5. To date, EPA Region 6 has not eliminated carbon capture sequestration from its BACT determinations based on technical infeasibility for combined cycle power plants. Since this is a proposed natural gas combined cycle power plant, please provide additional details, for BACT purposes, on the economics of installing a CCS system at the plant.

The combustion of natural gas at the proposed Lon C. Hill Power Station will produce an exhaust gas with a maximum CO₂ concentration of 4.5 volume percent. This low concentration stream will require that a very high volume of gas be treated so that the CO₂ may be captured effectively. However, the CO₂ capture capacities used in current industrial processes are designed for relatively high CO₂ concentration streams (25 percent or higher), as discussed in the "Report of the Interagency Task Force on Carbon Capture and Storage" (August 2010).

Figure 1 – Existing and Planned CO₂ Pipelines in the United States

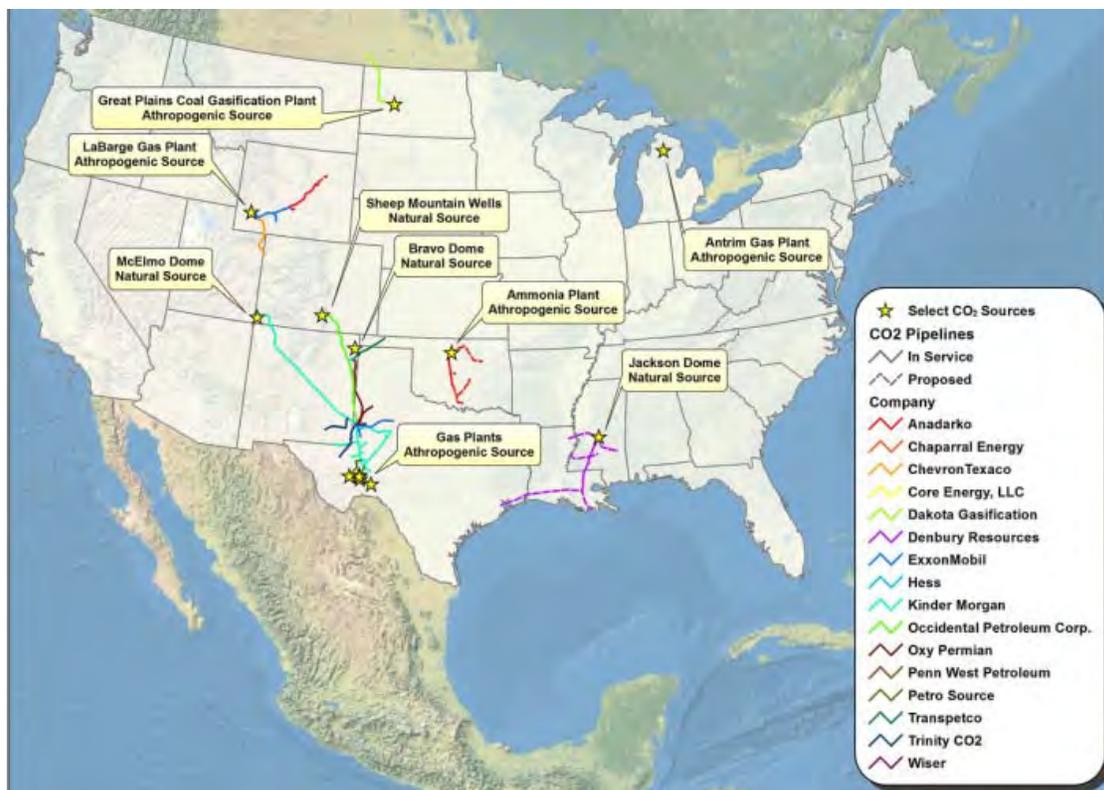
- (a) Specifically, please provide the site-specific information on the estimated concentration of CO₂ that is in the waste stream.
 - (b) Also, please provide site-specific cost calculations including, but are not limited to, size and distance of pipeline to be installed for potential enhanced oil recovery (EOR) opportunities, estimated costs for a capture system (pumps, compressors, amine solution) that specifically identifies the equipment necessary to employ a post-combustion CCS system.

Even if it is assumed that CO₂ capture could feasibly be achieved for the proposed project, the high-volume CO₂ stream generated (maximum 45,807 scf/min of CO₂) would need to be transported to a facility capable of storing it. Figure 1 is a map showing the location of current CO₂ pipelines in the United States.

As shown on this map, there are no existing pipelines that could transport the CO₂ stream from the proposed plant to any potential storage facility. The closest site to the proposed project, with some demonstrated capacity for geological storage of CO₂, is the Scurry Area Canyon Reef Operators (SACROC) oilfield near the eastern edge of the Permian Basin in Scurry County, Texas¹. This site is over 390 miles away from Lon C. Hill Power Station; therefore, a very long and sizable pipeline would be required to transport the large volume of high pressure CO₂ from the plant to the storage facility which will make CCS economically infeasible. Several other candidate storage reservoirs exist within 10 to 50 miles from the proposed project along the east Texas’ basins (see Figure 2); however, none have been confirmed to be viable for large scale CO₂ storage at this time.
